AGENDA
CHASKA PLANNING COMMISSION
ONE CITY HALL PLAZA, CHASKA CITY HALL
Wednesday, February 12, 2020
7:00 PM

**CHASKA PLANNING COMMISSION
MINUTES
January 08, 2020**

Subject: Chaska Bluffs 2nd – Concept Plan

Subject: QualiTech, Inc – Preliminary Site & Building Plan

TREE PLAN
 CHASKA BLUFFS 2ND ADDITION
 DDK CONSTRUCTION

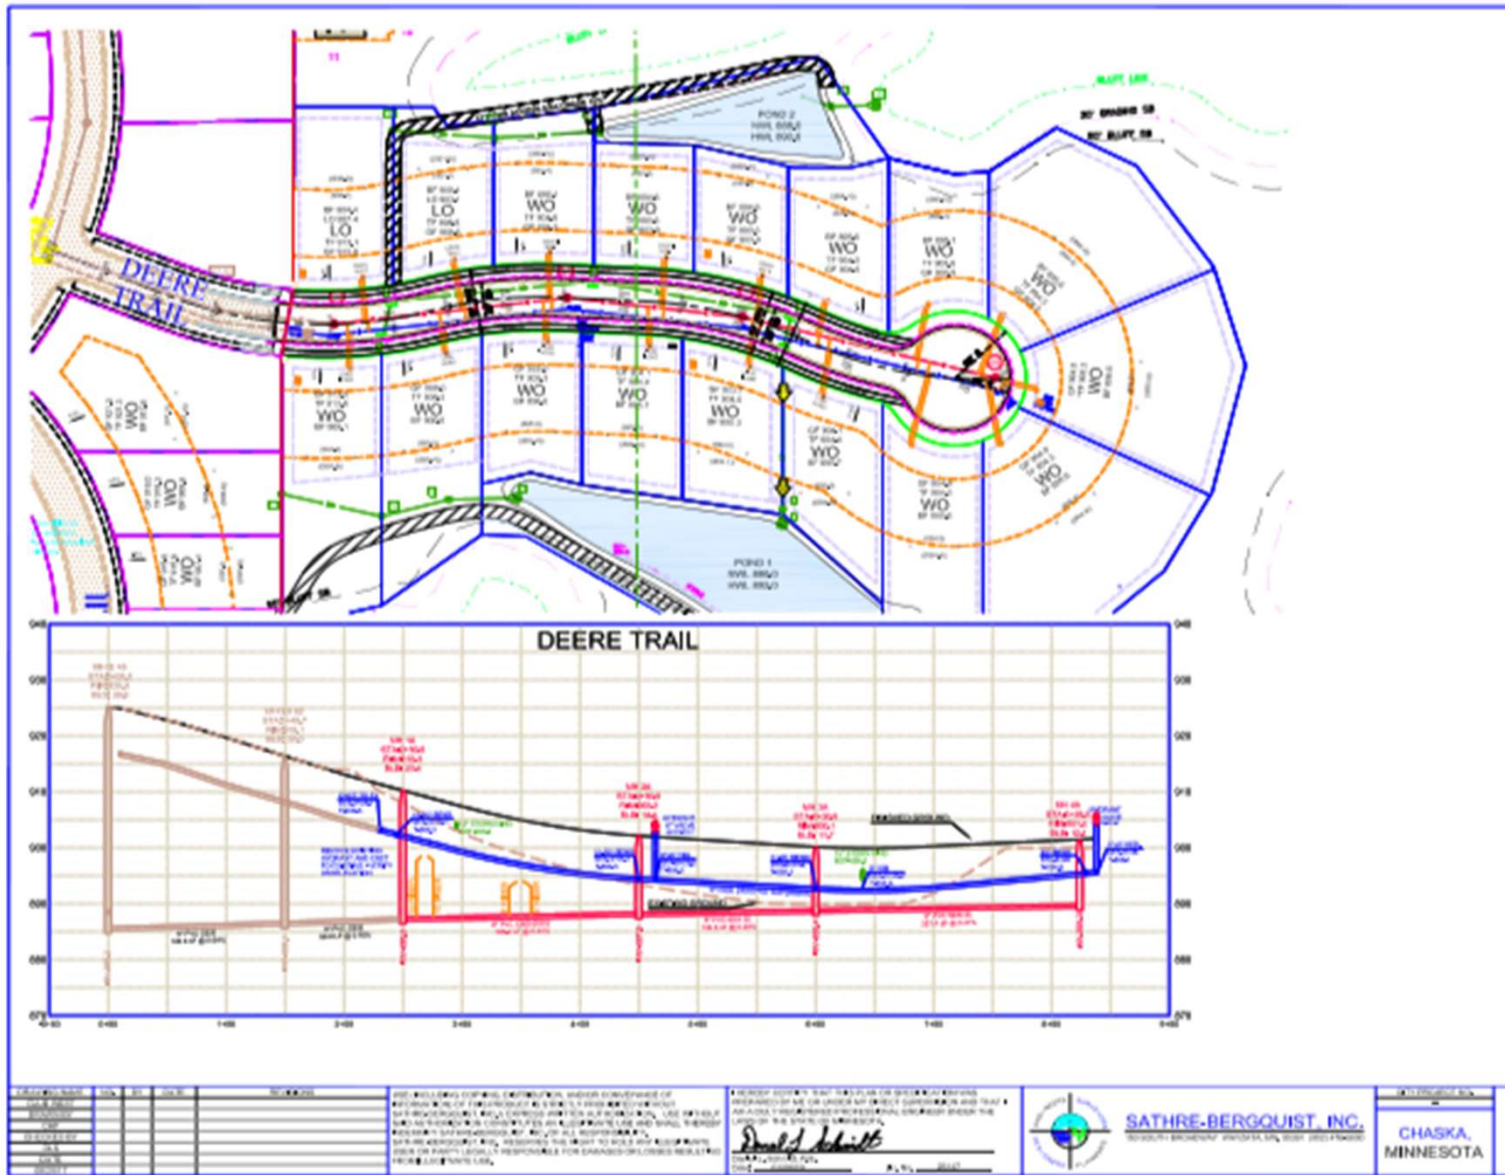
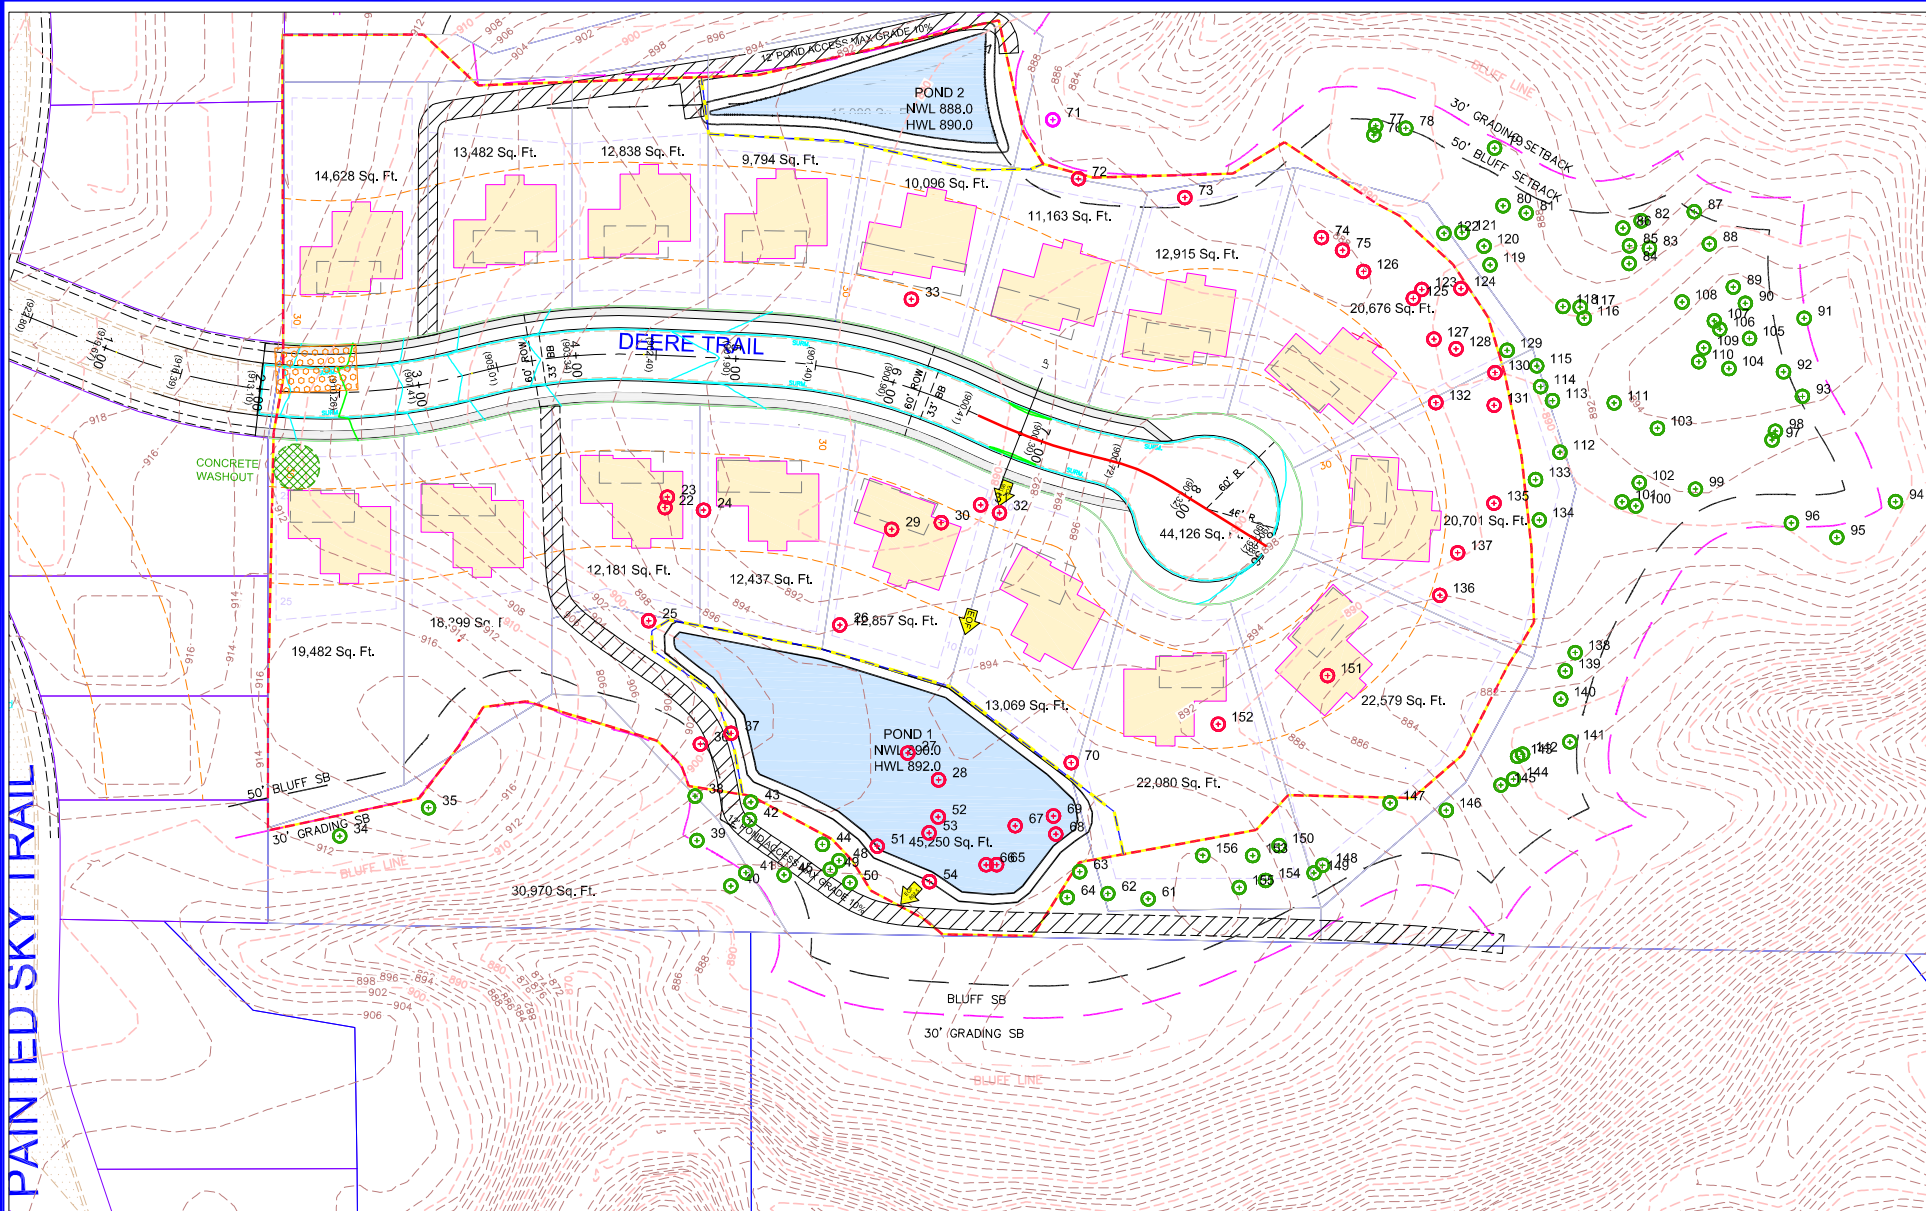
The tree plan and tree inventory provided indicates that some of the trees are planned to be removed as a part of this project. Staff analyzed the tree inventory and it was concluded that approximately 42 significant trees (12 inch caliper or more) will be removed as a part of this development. The majority of those trees are cottonwoods, box elders, and aspens. 12 of those are oaks, which average at 15 inch calipers. The developer has pulled the development back from the easterly edge of the bluff line to preserve a large area of trees that were otherwise not protected by ordinance; there are approximately 85 saved trees in this area. This area includes a majority of red oaks (44 of them). In staff's opinion the developer has provided a plan that starts to make good efforts in preserving significant areas, which will be along the perimeter of the site and in the rear of the lots. There are no trees planned to be preserved in the front or side yards of these lots as there were no unique clusters identified in such areas.

Most of the preserved trees fall outside the proposed property lines of the lots. The developer plans to dedicate the bluff areas to the City, as well as the preserved wooded areas outside of the lots. There are some wooded areas planned for preservation that encroach into the rear yards of the lots. Staff would recommend that these lots' property lines be revised so that the wooded areas fall completely within City ownership. If not, they will require a conservation easement over them.

11. Preservation of trees as noted in the Tree Plan T1 and T2.
12. LP Smartside to be used on front elevations.
13. 4-inch window trim to be used on all windows.

23. Provision that the property lines of the lots are revised to be outside of the preserved wooded areas and be revised on the plans for preliminary submittal.

CONCEPT SKETCH
CHASKA BLUFFS 2ND ADDITION
DDK CONSTRUCTION, INC.

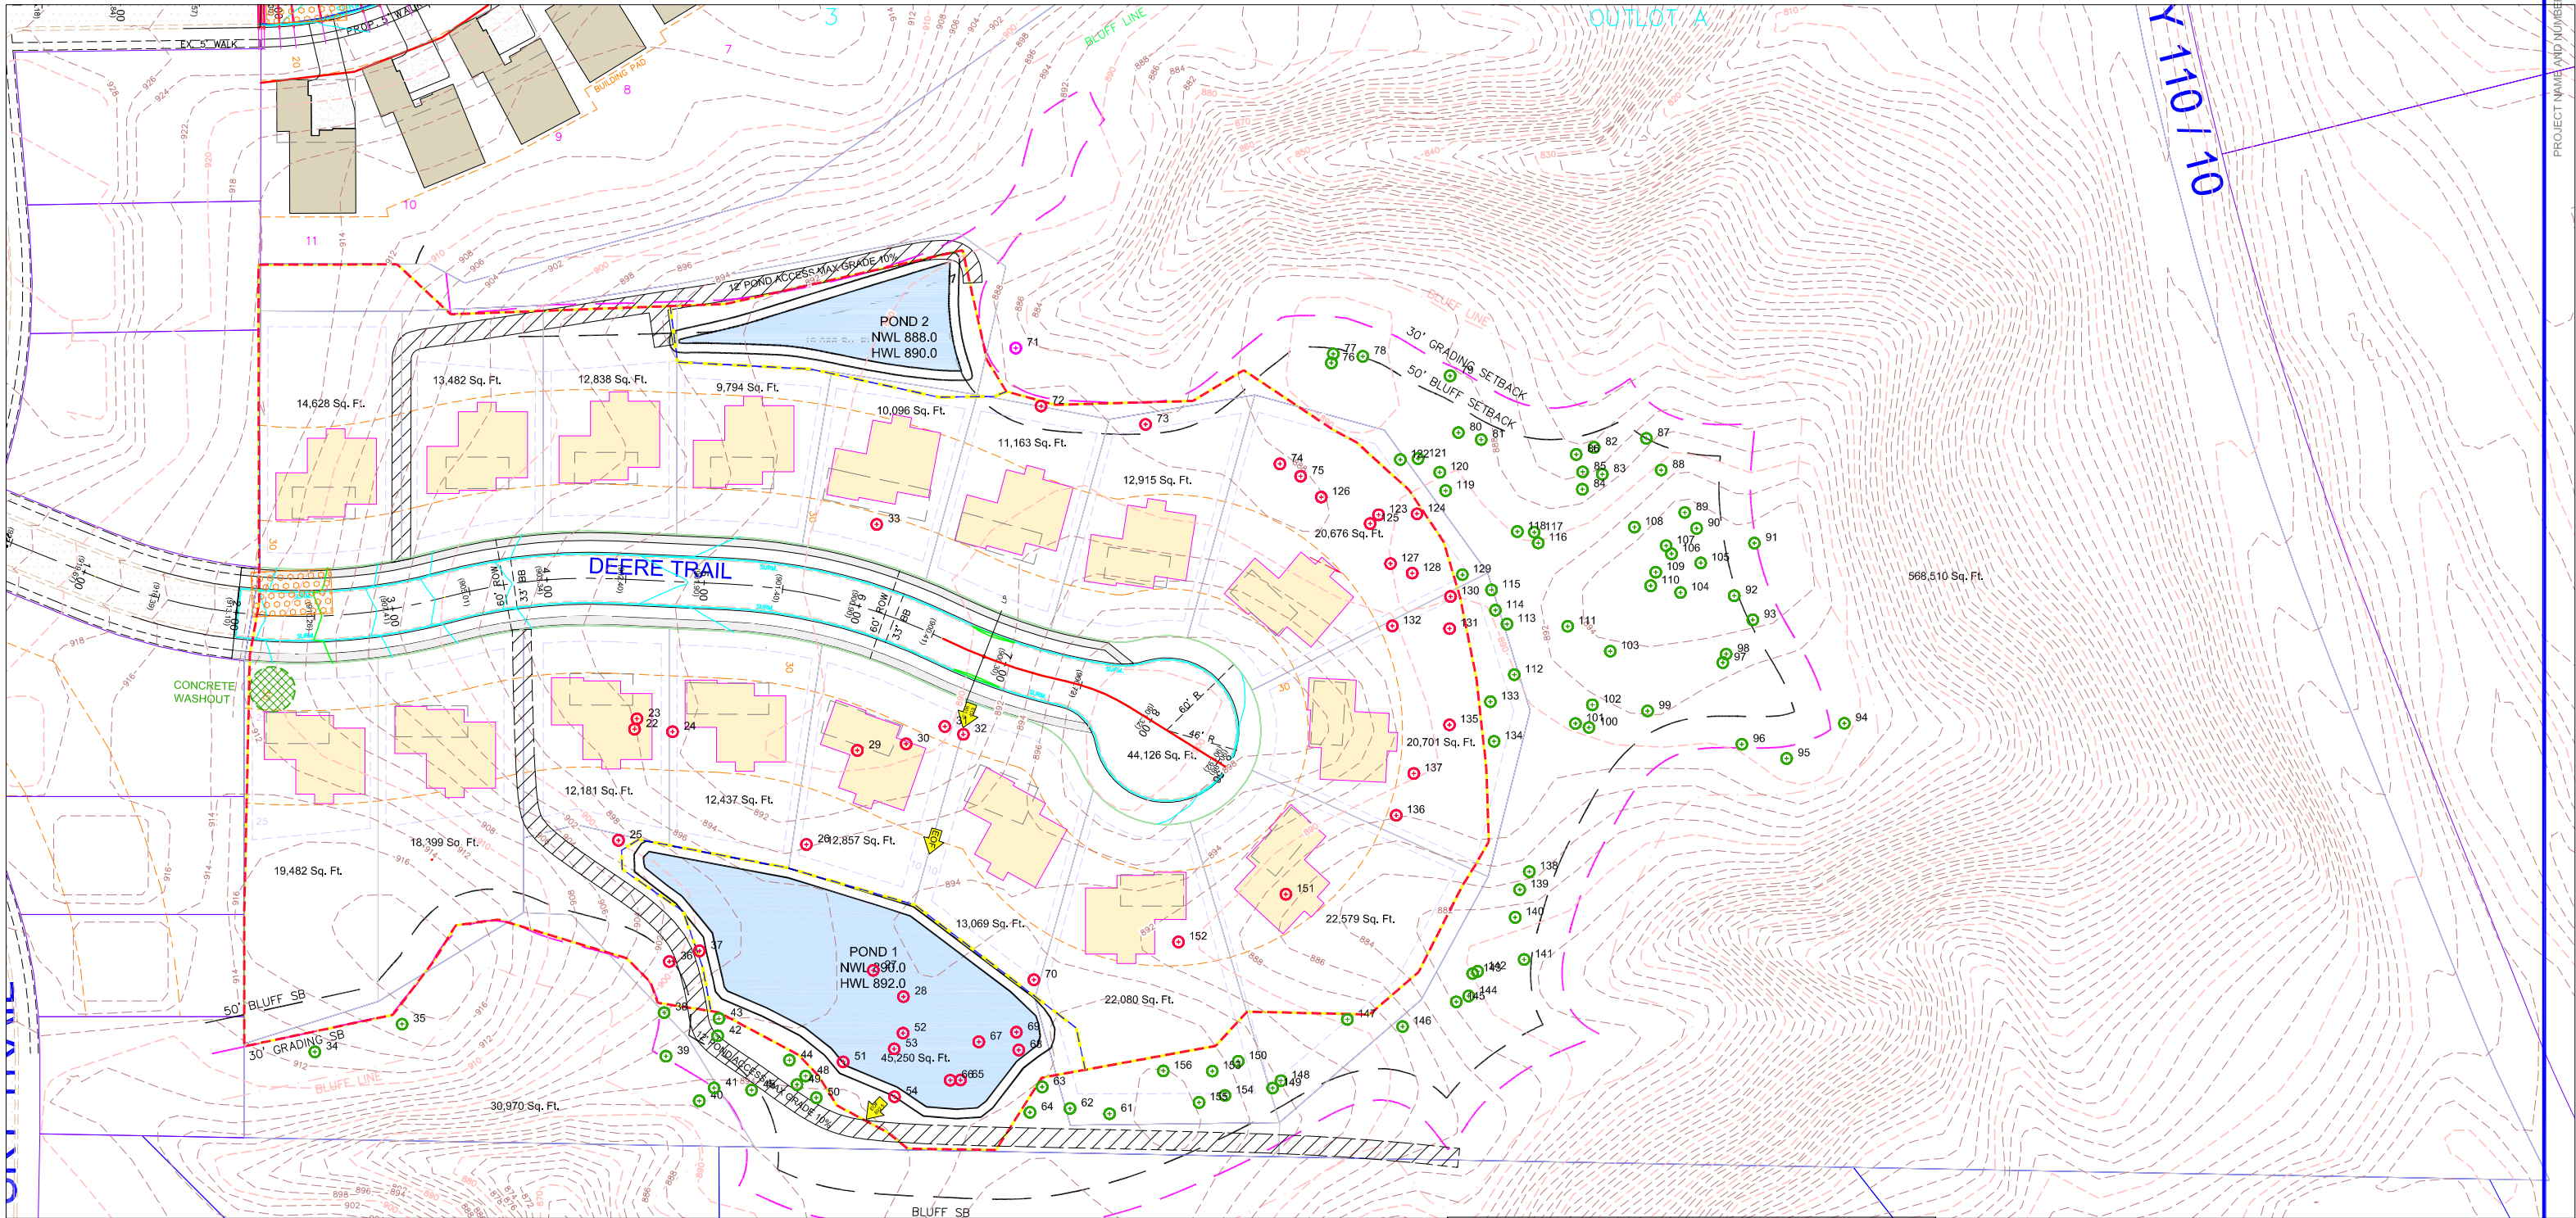
As noted on the Concept Sketch there are two dump areas that have been found in the bluffs. This is not uncommon in the natural areas of the City but when they are found and attached with a development then they are required to be cleaned up. The developer has stated in their narrative that these areas will be corrected. As is customary, we will need a remediation plan submitted for preliminary to entail how these dump sites will be cleaned, and ensure that they will not contaminate the natural area.

It is not ideal nor practical to incorporate maintenance accesses through private lots to access City ponds. It makes it rather difficult for city crews to access these areas and could also be an unnecessary burden on the homeowner in terms of fencing limitations and potential easement restrictions. Staff would require that these pond accesses are located entirely within outlots owned by the City. It would also be encouraged to provide access routes that are the least invasive in terms of location. The northern pond's access seems rather long and separated. It would appear more practical to locate this access point between lots 3 and 4 as denoted on the Concept Sketch to create a less invasive travel path. It appears that the maintenance access on

the north side also shows encroachment into the 30 foot no grade/no mow setbacks which is not allowed. The developer will be required to revise this access to be outside of this setback.

19. Provision of a wetland delineation report to be completed and submitted at preliminary submittal.
20. Provision to revise the maintenance accesses to be in the least invasive location, particularly locating the northerly maintenance access between lots 3 and 4 as denoted on the Concept Sketch.

21. Provision that maintenance accesses do not encroach into 30 foot no grade/no mow setback and be revised on the plans for preliminary submittal.
22. Provision that all lots' property lines do not encroach into the 30 foot no grade/no mow setback and be revised on the plans for preliminary submittal.
